SERVICE BULLETIN

TR-2400

#815

SUBJECT: TR-2400 PULSE NOISE

TX-RX UNIT

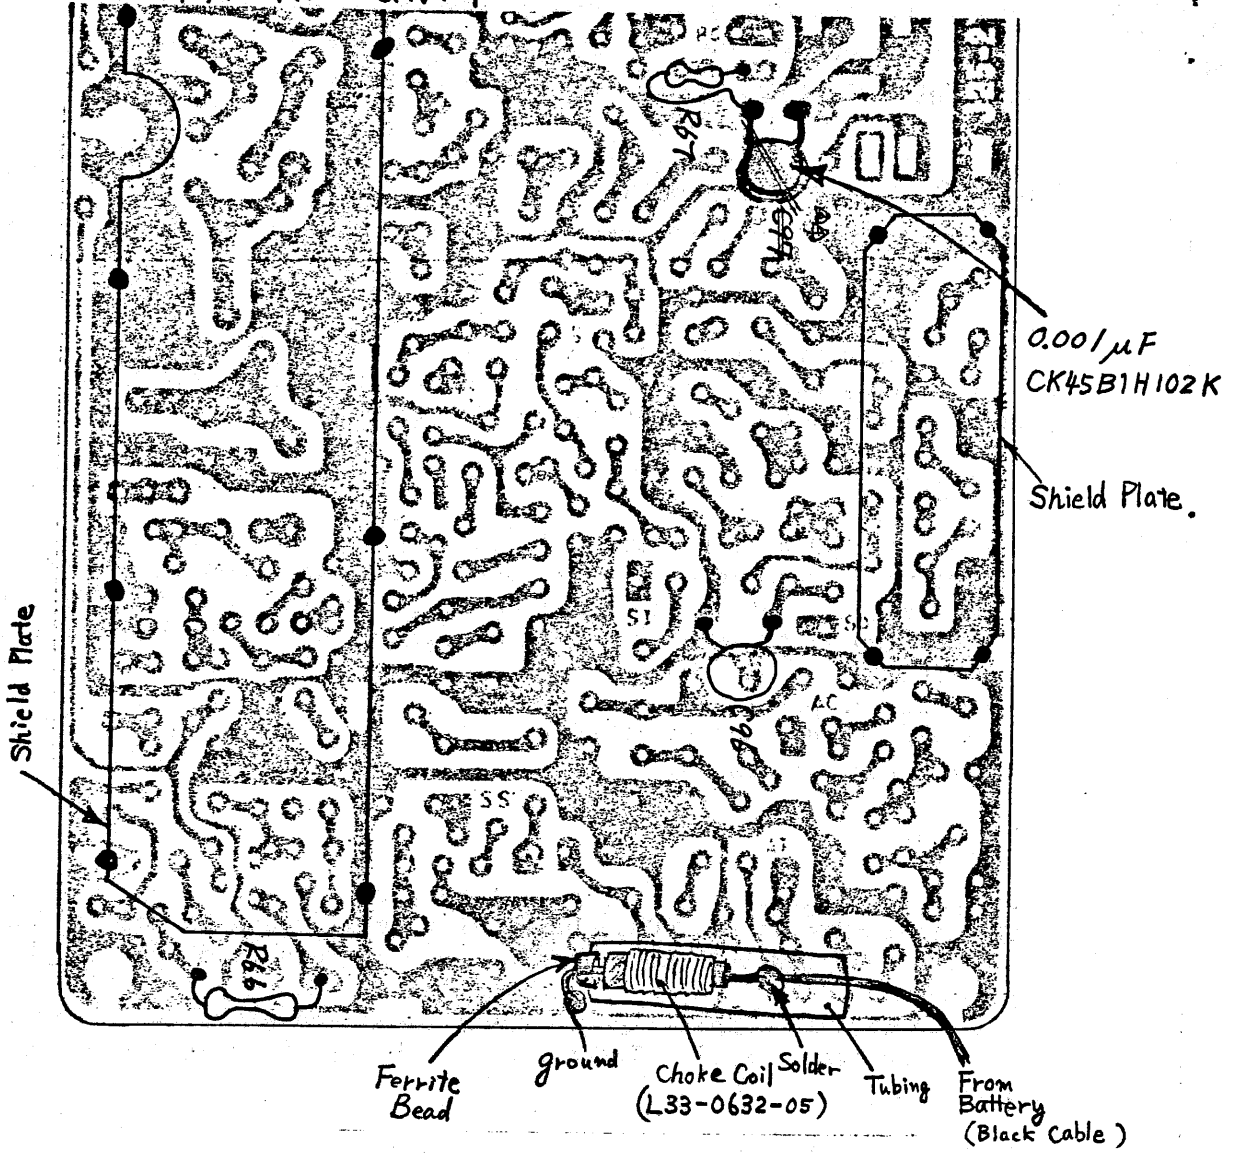
TX RF NOISE:

1. On the RX TX unit, locate the battery ground (BLACK) lead soldered to the right edge of the PCB. Desolder this line and install a choke with ferrite bead L33-0632-05 Resolder along the bottom edge of the board, as shown.
2. Also on the RX TX unit, locate the YELLOW lead attached to the foil side of the charge jack J1. Install a .001uF capacitor across J1 to ground as shown.
